PROPOSED BROWSE TO NORTH WEST SHELF PROJECT

Environment Review Document - Response to
Submissions (EPA Assessment No. 2190)

November 2023

Figure 3-1 Annual average results from MODU NO₂ modelling showing exceedances of current NEPM thresholds (red) and future NEPM thresholds (orange)

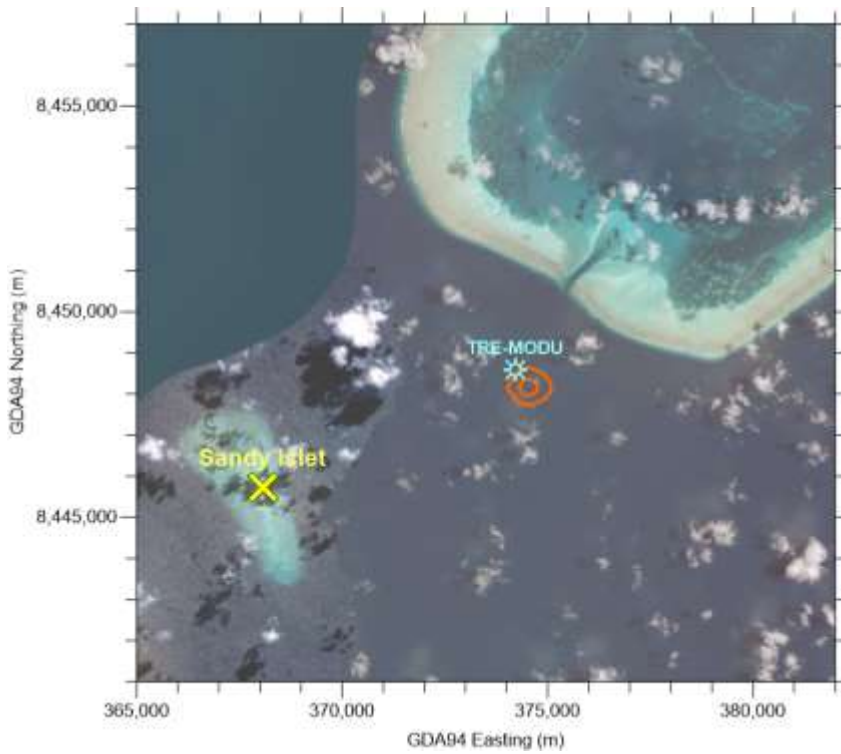
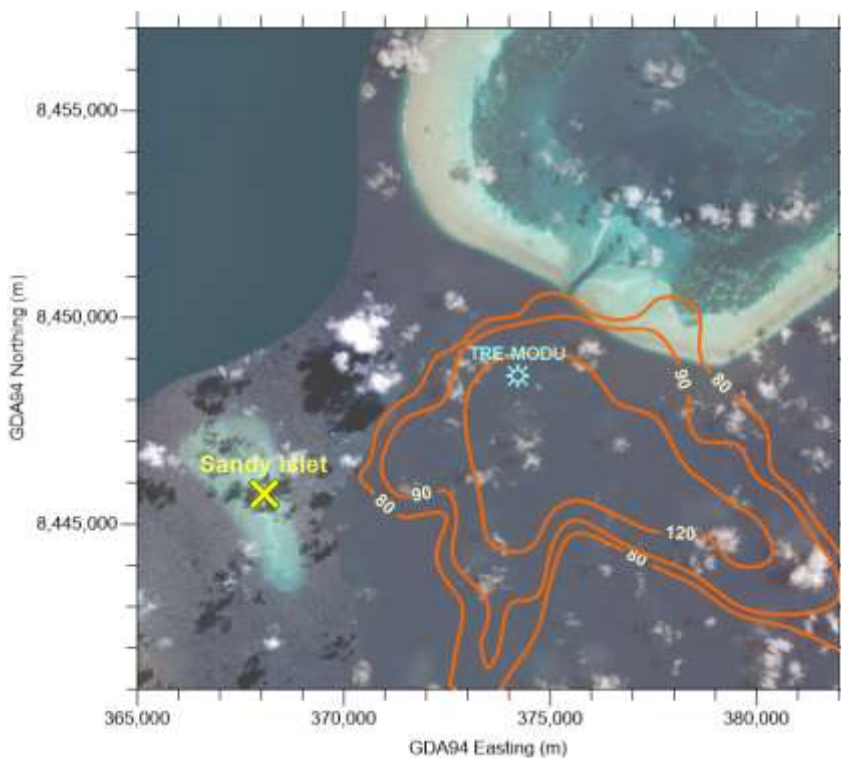
EPA comments	Proponent’s response
Factor 1: Air Quality		
1	<p>Details of a quantitative air quality assessment (modelling of NO2 emissions from routine MODU and production platform power generation for an offshore project undertaken by another operator (BP, 2013) has not been provided in the EIS/ERD to support the conclusion that risks are negligible for this component of the project.</p> <p>Provide further details to support the conclusion that the risks are negligible.</p>	<p>The BP (2013) study is considered a good analogue for the proposed Browse Project as it included consideration of two MODUs operating simultaneously, which may occur during the life of the proposed Browse Project (at different drill centres). The proposed Browse Project drilling locations are around ten times further from sensitive receptors (i.e. populated coastal areas) than the BP modelled locations.</p> <p>Further details of the BP (2013) study referenced in Section 6.3.5 the draft EIS/ERD can be found in Chapter 9 (Drilling and Completion Environmental Impact Assessment, Mitigation and Monitoring) of the publicly available “Shah Deniz 2 Project Environmental & Socio-Economic Impact Assessment”, which is available at https://www.bp.com/content/dam/bp/country-sites/en_az/azerbaijan/home/pdfs/esias/sd/sd2/9_drilling_eia.pdf</p> <p>To provide further evidence to support this description of the source of aspect, additional modelling considering local Browse meteorological conditions and MODU assumptions has been conducted to further support the impact assessment. The full modelling report is included in Error! Reference source not found..</p> <p>Modelling Scenario</p> <p>Modelling considers a scenario which has been more specifically tailored to the proposed Browse Project:</p> <ul style="list-style-type: none"> • A single MODU has been modelled at TRE (the closest location to Sandy Islet, considered to be the nearest nesting and/or roosting site for seabirds and migratory shorebirds).

EPA comments	Proponent's response
		<p>The emissions rates assumed, and emissions factors used for the purposes of modelling are presented in Table 3-2.</p> <p>Impact Assessment Approach</p> <p>While there are no established thresholds applicable to seabirds for impacts from NO₂, the draft Air Emissions Guideline published by DWER reference the National Environment Protection Measure (NEPM) air quality standards for NO₂. These air quality standards have therefore been used for the purposes of modelling and impact assessment. This is considered to be a conservative approach, as the NEPM thresholds are intended to ensure that there is adequate protection of human health and the environment under chronic exposure scenarios (ie residents near an industrial facility), whereas drilling campaigns are of limited duration. It should also be noted that atmospheric emissions are not identified as a threat to seabirds in the Draft Wildlife Conservation Plan for Seabirds (Commonwealth of Australia, 2019) or in the Wildlife Conservation Plan for Migratory Shorebirds (Commonwealth of Australia, 2015a).</p> <p>This is particularly true for the modelled scenario at TRE, as drilling at TRE is constrained through additional controls presented in the Response to Submissions (ie drilling and completions activities at TRE will occur outside of the peak pygmy blue whale migratory periods (May, June and November) and outside the Sandy Islet green turtle peak nesting and hatchling emergence period (January – April). The NEPM air quality standards have both an annual average threshold and a 1-hr max threshold.</p> <p>Modelling Approach</p> <p>Meteorological modelling for Scott Reef was conducted using the CSIRO's 'TAPM' meteorological and air dispersion model (Hurley, 2008a, 2008b; Jacobs, 2019) on the basis that this model provides adequate granularity to screen out potential impacts from NO₂ beyond that currently described in the draft EIS/ERD. TAPM was used to produce 3-dimensional, hourly-varying, simulated meteorology specifically for the Scott Reef study area, with the inner-most modelling grid 25 km by 25 km in area. Twenty vertical layers were included from sea level to a height of 8000 metres (m). The TAPM photochemical module GRS was used to improve the predicted NO₂ concentrations for Scott Reef by including the effects of O₃ more explicitly. Further, TAPM results for predicted wind speed and wind direction for Scott Reef including comparisons with measurements obtained at Scott Reef in 2006-2007 (RPS MetOcean, 2008).</p>

EPA comments	Proponent's response
		<p>Model Results</p> <p>Modelling was conducted separately to produce average annual and 1-hr max sea-level concentration results in the ambient environment. Neither current nor future NEPM air quality standards for average annual or one-hour max results were exceeded at Sandy Islet.</p> <p>Average annual results (Figure 3-1) using the TAPM-GRS (photochemical) modelling indicate no exceedance of current NEPM air quality standards at sea level. Future NEPM air quality standards may be exceeded up to 1,025m away from the MODU.</p> <p>One hour max results (Figure 3-2) indicate an exceedance of current and future NEPM air quality standards at sea level further away (up to 7,580 m and 10,400 m from the MODU respectively), extending furthest in a southeasterly and southerly direction. It should be noted that the 1-hour modelling shows the maximum average concentration for a particular cell on the grid over any 1-hour duration in the modelling results over an entire year. Therefore, the image does not represent a single set of metocean conditions (i.e. prevailing wind direction), but rather the metocean conditions that achieve the highest concentration at each individual grid cell.</p> <p>Discussion</p> <p>As discussed within Section 5.3.2.4.1 of the draft EIS/ERD, seabirds around Scott Reef are predominately associated with Sandy Islet, a part of South Scott Reef, and occur in small numbers in comparison to other breeding and roosting sites in the region. Smith et al. (2004) recorded little tern (500 individuals), brown booby (6), ruddy turnstone (50), Australian lesser noddy (200) and the common noddy (30) during a survey at Scott Reef in 2003. Seabird surveys conducted at Scott Reef observed greater numbers of birds during spring than winter (Jenner et al., 2009). Seabird species typically roost on Sandy Islet at night and are presumed to forage in nearby and offshore waters during the day. It is not currently known if any of the observed species are permanently resident on Sandy Islet.</p> <p>The environmental impact assessment for air emissions from offshore activities in the draft EIS/ERD (Section 6.3.5.3) identified that: <i>Atmospheric emissions from the proposed Browse Project have the potential to result in a localized reduction in air quality in the immediate vicinity of the release point. While a slight reduction in air quality on a local scale will occur for the duration of the activities, given the low</i></p>

EPA comments	Proponent's response
		<p><i>emissions levels, very low background levels of pollutants and distance from the emissions sources to the nearest environmental sensitive receptors, it is not anticipated that emissions from the proposed Browse to NWS Project will result in lasting effect on air quality locally or regionally.</i></p> <p>Given that the results of NO₂ modelling indicate that NEPM air quality standards are not expected to be exceeded at Sandy Islet, the results of the modelling provide further confidence in the environmental impact assessment presented in the draft EIS/ERD. It is also noted that the TRE drill centre is no longer proposed. It should also be noted that MODU campaigns are of limited duration, and that therefore the above results are inherently conservative. No lasting impact to seabirds and migratory shorebirds as a result of atmospheric emissions is expected. As such, monitoring of bird species present within the Scott Reef complex to assess the potential impacts and risks to seabirds and migratory bird species resulting from air emissions from the proposed Browse Project is not considered warranted.</p>

Figure 3-3 Proposed State Proposal Area LEPs – Construction

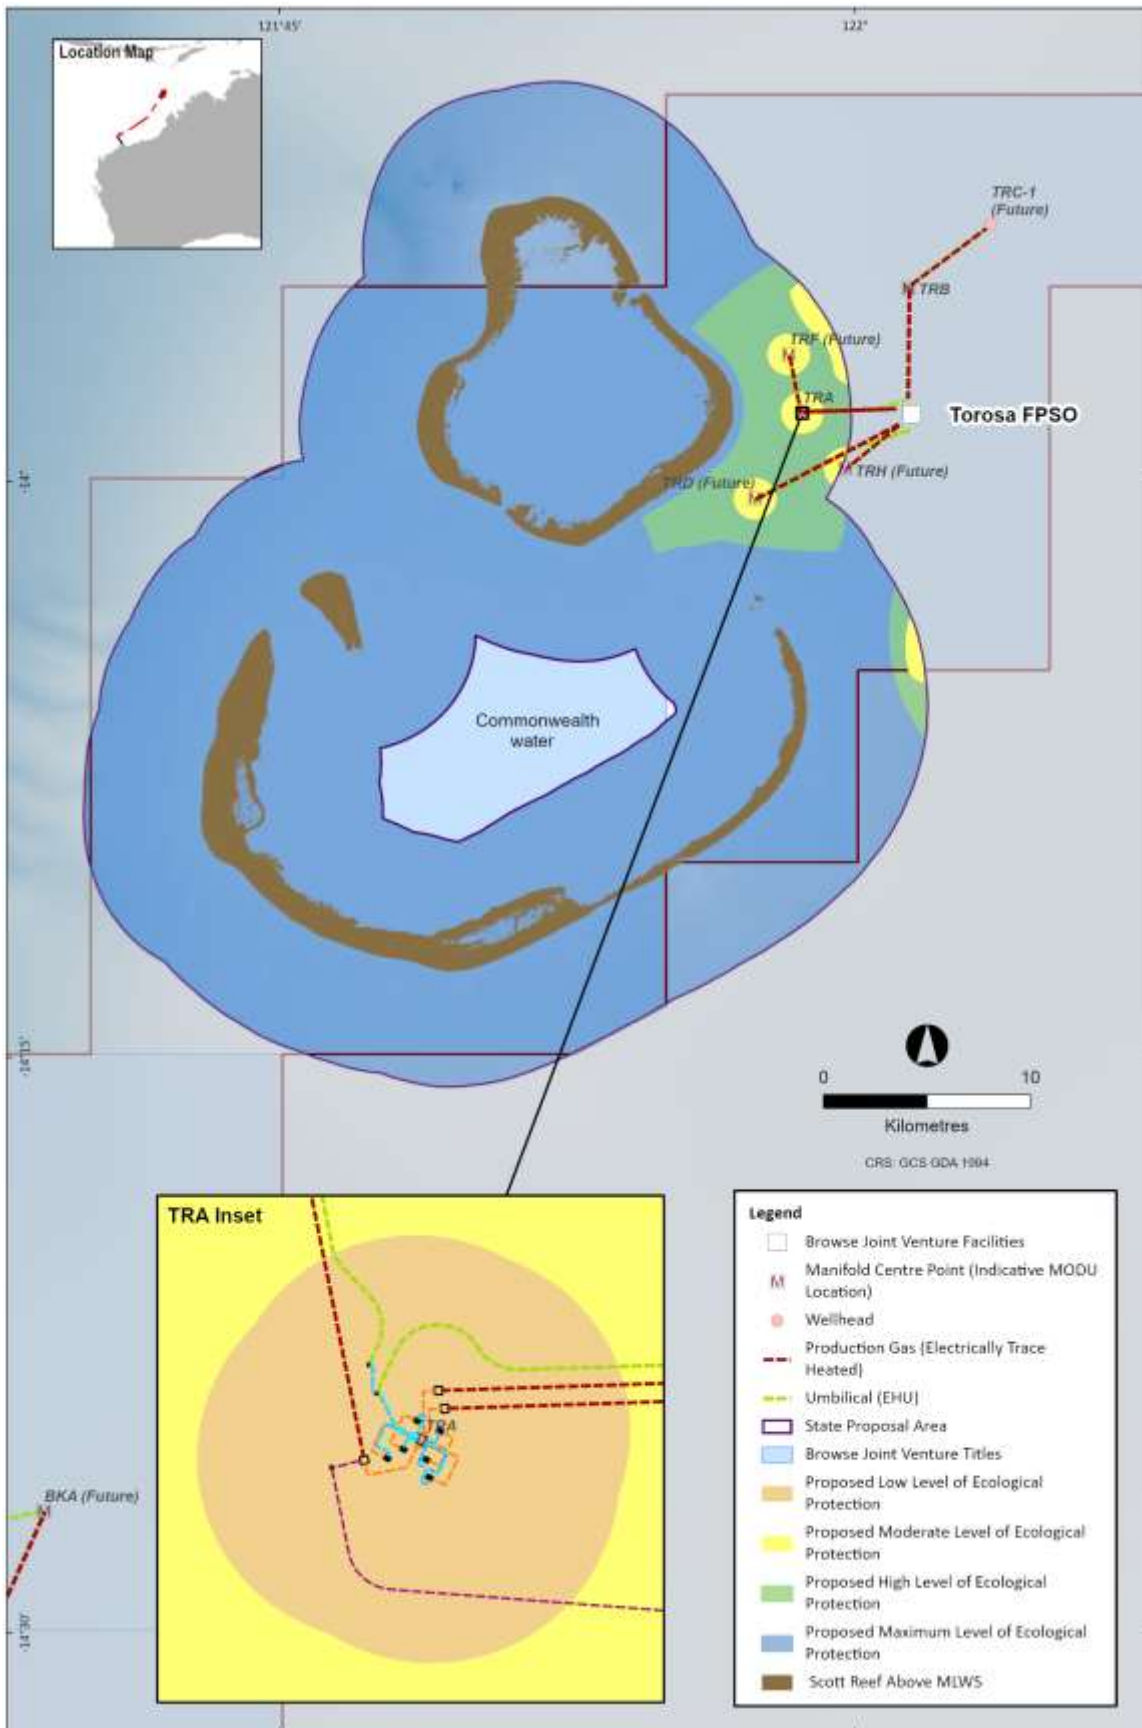
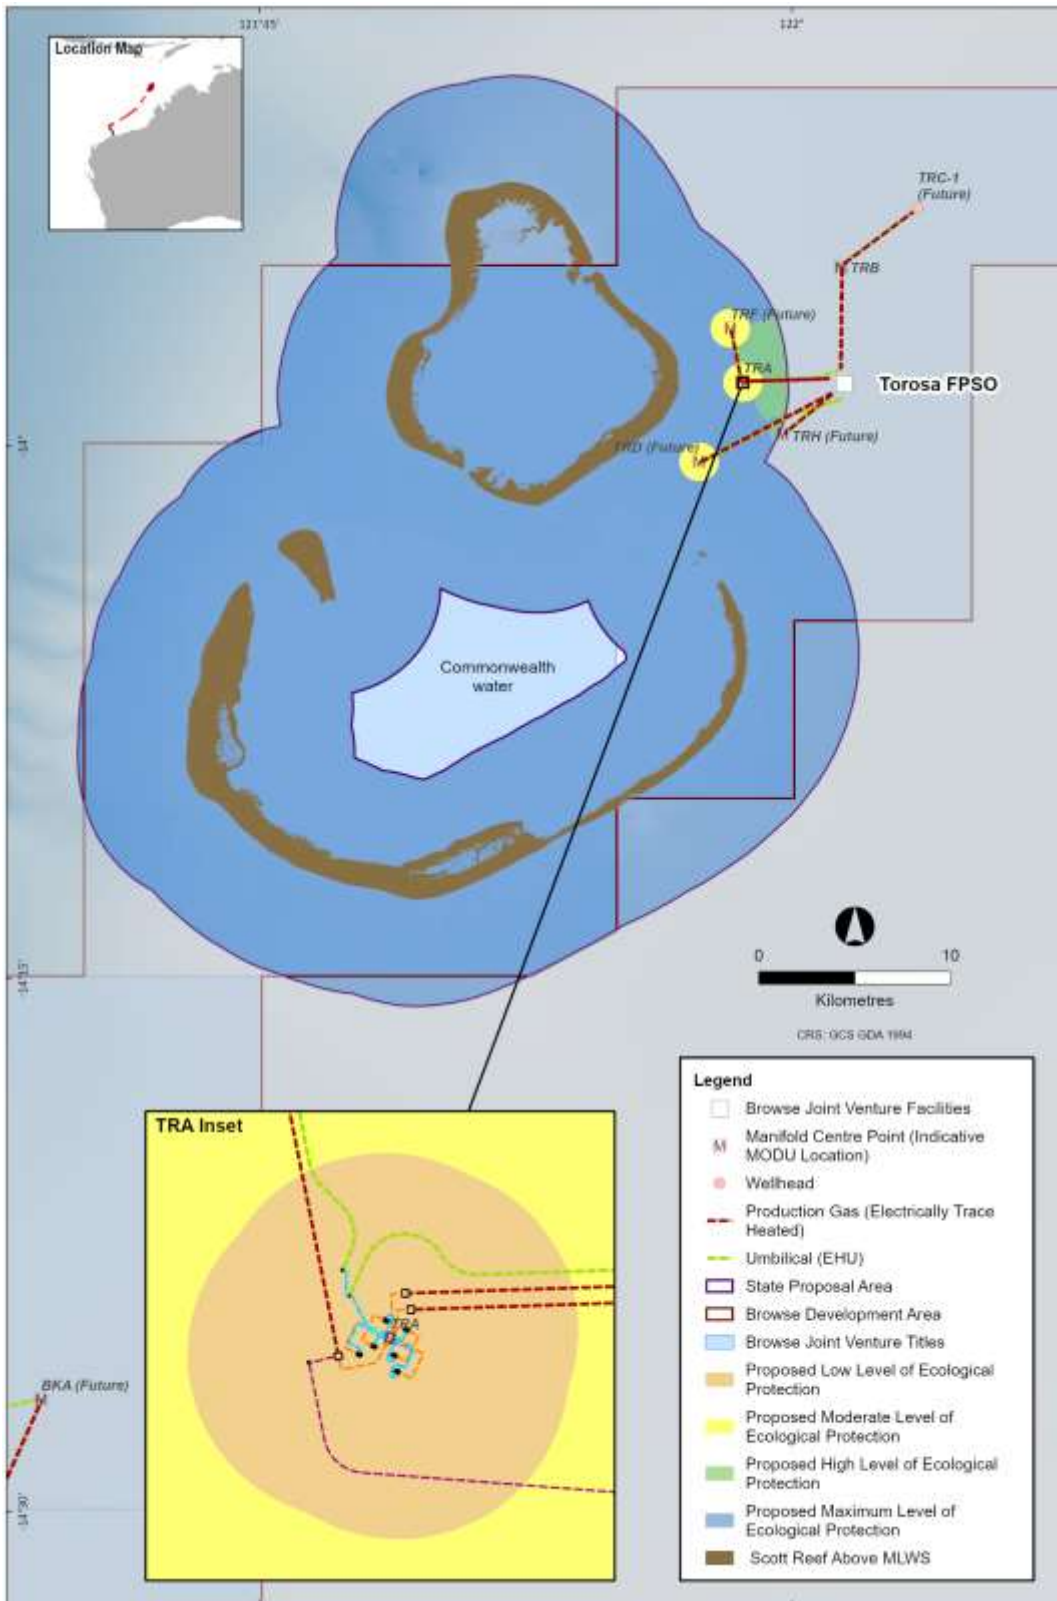
EPA comments	Proponent's response
		<p>95% of the time based on dispersion modelling results, which will be verified through monitoring.</p> <p>An overview of the monitoring to support this adaptive management strategy is provided in Table 6-101 and Table 6-102 of the draft EIS/ERD for FPSO PW and Table 6-110 for FPSO cooling water and stated below.</p> <ul style="list-style-type: none"> • <i>During steady state FPSO operations, PW modelling and infield verification will be completed to verify the modelling predictions.</i> This study aims to verify the modelling predictions and in particular the dilutions achieved, which determines the point at which the defined thresholds levels are reached. • <i>Periodic and 'for cause' toxicity testing and characterisation of the physical and chemical composition of the FPSO PW stream prior to discharge will be undertaken.</i> This provides an assessment of the individual constituent chemical concentration and the whole of effluent toxicity at end of pipe. • <i>Baseline and periodic water and sediment quality monitoring at a gradient away from the FPSO facility in the receiving environment will be undertaken to detect changes as a result of FPSO PW discharge.</i> This gradient will extend to the point at which environmental quality meets the guidelines and standards required for the designated LEP in the State Proposal Area are achieved. This monitoring aims to determine no changes in the receiving environment water and sediment quality outside of the defined mixing zone as a result of the FPSO PW discharges. • <i>In the event the PW discharge does not meet the defined thresholds in the range predicted for any constituent concentrations, an adaptive management strategy will be implemented which will be included during the EP process for the Torosa FPSO.</i> This adaptive management strategy will include actions such as reducing the discharge rate, which increases dilutions in the nearfield or reduces an individual chemical concentration through commingling prior to discharge, or the addition of new/additional treatment stages or equipment. It should also be noted that PW will come on slowly over a period of many years so there will be opportunity to sample and adapt before the full rates modelled later in field life are experienced. <p>Note, the infield verification will be completed using proven monitoring techniques to verify the model predictions and confirm that the mixing zone, including at the 3 nm State waters boundary, is met. In the event that the mixing zone is larger than anticipated, posing a significant increase in impact than that described in this draft</p>

EPA comments	Proponent's response
		EIS/ERD, then corrective actions will be implemented onboard the FPSOs to reduce the impact. Corrective actions include additional engineering to produce a change in discharge characteristics as described above.
6	<p>Consistent with the EPA's Technical Guidance for Protecting the Quality of Western Australia's Marine Environment (EPA 2016), an Environmental Quality Plan (EQP), that identifies the environmental values to be protected and spatially maps the environmental quality objectives and levels of ecological protection that should be achieved, should be included to inform the assessment.</p> <p>The areas proposed in the EIS/ERD as High and Moderate Ecological Protection are large and needs to be justified. For example, a 1000 m radius is proposed for moderate ecological protection around each drill centre. No rationale is provided for the size of this area and it is noted that the modelling predictions for drill cutting discharge at the sea bed are much smaller 1000m. The installation of subsea infrastructure is provided as one justification for part of the area of Moderate Ecological Protection. However, it should be noted that the levels of ecological protection should be defined based on levels of environmental quality that will be achieved, not areas of physical disturbance. Finally, the areas of high level of ecological protection should be consistent with the model outputs for the discharges.</p>	<p>An Environmental Quality Management Plan (EQMP) is provided in Error! Reference source not found.. The EQMP is an operational plan and will be refined following an assessment decision and over the life of the proposed Browse Project. The LEP proposed in the draft EIS/ERD have been reviewed and refined with LEP justifications provided within the EQMP. This refinement has been undertaken in consideration of the levels of environmental quality that are predicted to be achieved as per the EPA's Technical Guidance for Protecting the Quality of Western Australia's Marine Environment (EPA, 2016). Given the detailed information provided in the draft EIS/ERD, including proposed LEP and their zonation, it is considered the consultation on the contents of the EQMP has been undertaken via the draft EIS/ERD public comment period and regulator engagements.</p> <p>With respect to the specific example raised (i.e. moderate LEP around drill centres), it should be noted that the actual expected impact around each well is in the order of 200 m radius (based on modelling presented in Section 6.3.15.3 of the draft EIS/ERD and a 6.5 mm thickness threshold for ecological impacts from sediment deposition (IOGP, 2016)). However, given that the precise location of each well within proximity to the drill centre is not known, an area of 1000 m around each drill centre has been proposed with a 200 m low LEP area around each individual well, but the exact location of this LEP will only be known once well locations are chosen.</p> <p>The revised LEP are shown Figure 3-3 (construction), Figure 3-4 (drilling discharges water quality) and Figure 3-5 (operations). The basis of the proposed LEPs is described in Table 3-3.</p>
